SERVICE BULLETIN

APPLICABILITY: 2018-21MY Outback

NUMBER: 12-318-21

SUBJECT: Rear Bumper Reflex Reflector- Design Change

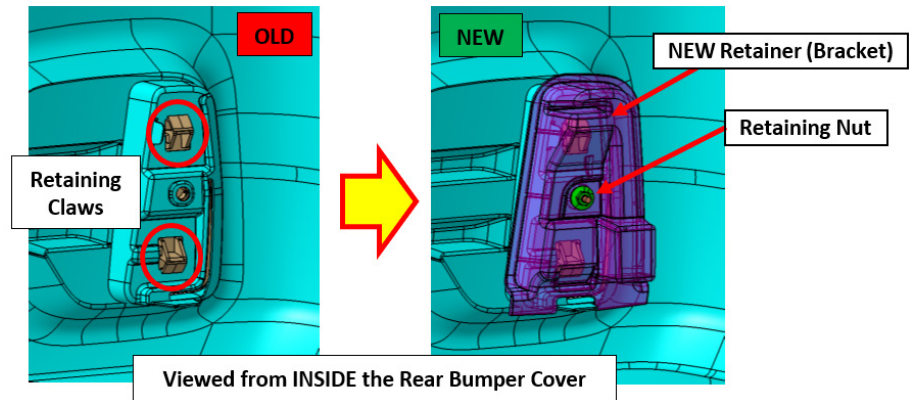
This bulletin outlines a design change to the rear bumper “Reflex Reflectors” made to enhance their retention into the bumper cover as shown in the photos below.

The new part utilizes an added retaining bracket combined with a stud and nut arrangement to supplement the “claw” (or snap-in) retention design.

The new-design reflector assemblies were incorporated into production starting with VIN **M3183715**.

2020-21MY OUTBACK WITH Reverse Automatic Braking (RAB):

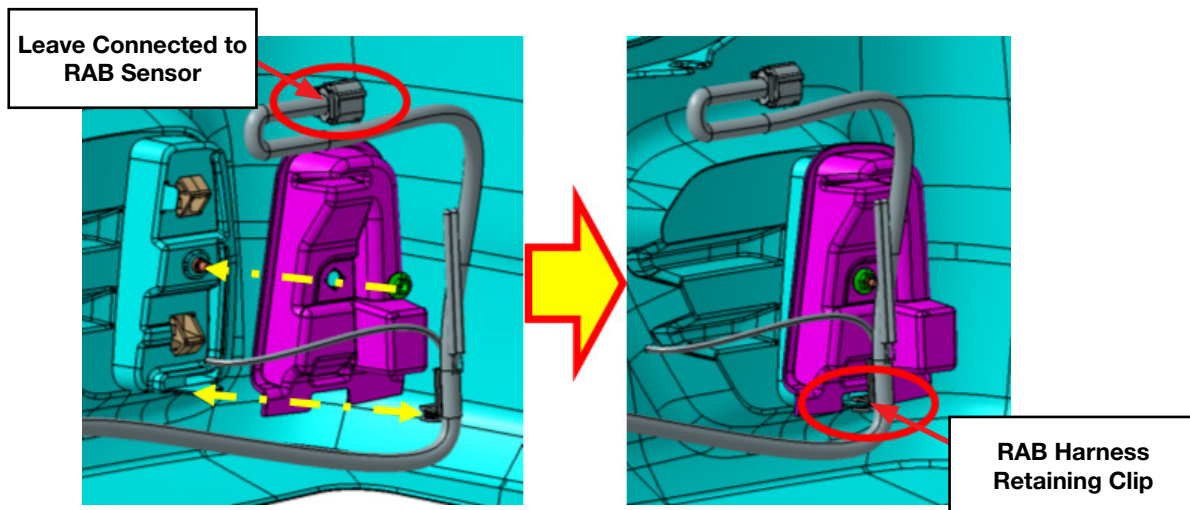
- 1) **CAREFULLY** remove the RAB harness retaining clip from the bumper cover.
- 2) Fit the new reflector assembly to the bumper making sure the retaining claws are fully seated.
- 3) Install the new bracket from the inside of the bumper cover as shown while paying close attention to not pinch the RAB harness between the bracket and the bumper cover.
- 4) Install the retaining flange nut and torque to 40 inch-pounds.
- 5) Re-secure the RAB harness to the bumper cover with the clip removed in 1) above.

2020-21MY OUTBACK WITHOUT RAB:

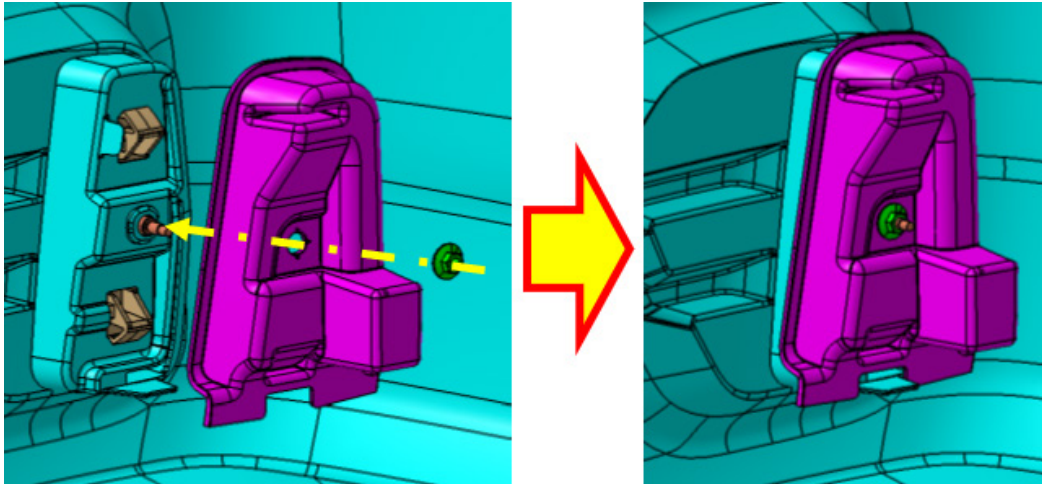
- 1) Fit the new reflector assembly to the bumper making sure the retaining claws are fully seated.
- 2) Install the new bracket from the inside of the bumper cover as shown.
- 3) Install the retaining flange nut and torque to 40 inch-pounds.

2018-19MY OUTBACK WITH RAB:

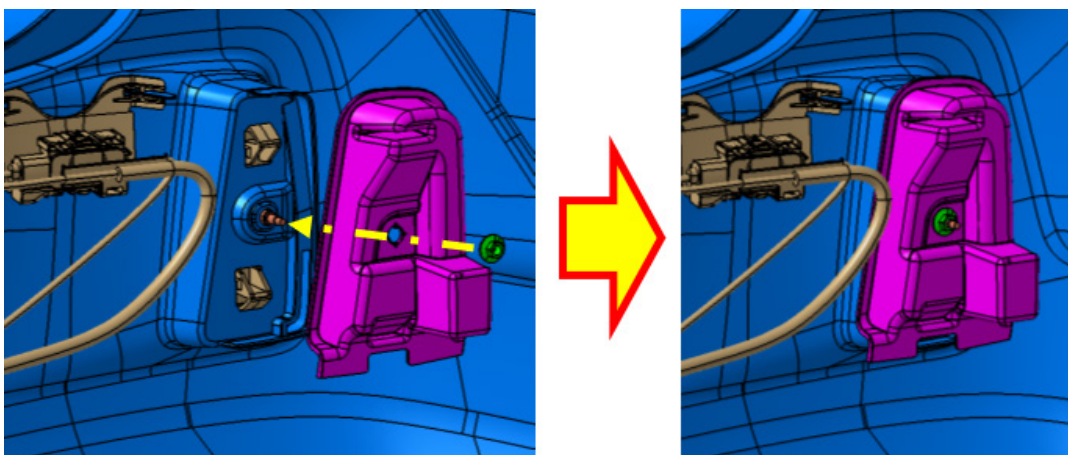
- 1) Fit the new reflector assembly to the bumper making sure the retaining claws are fully seated.
- 2) Install the new bracket from the inside of the bumper cover as shown while paying close attention to not pinch the RAB harness between the bracket and the bumper cover.
- 3) Install the retaining flange nut and torque to 40 inch-pounds.

2018-19MY OUTBACK WITHOUT RAB:

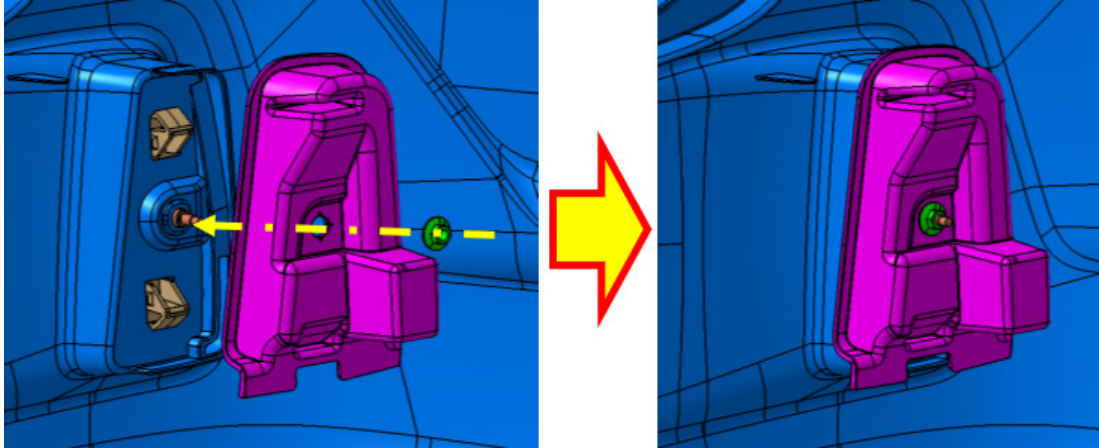
- 1) Fit the new reflector assembly to the bumper making sure the retaining claws are fully seated.
- 2) Install the new bracket from the inside of the bumper cover as shown.
- 3) Install the retaining flange nut and torque to 40 inch-pounds.
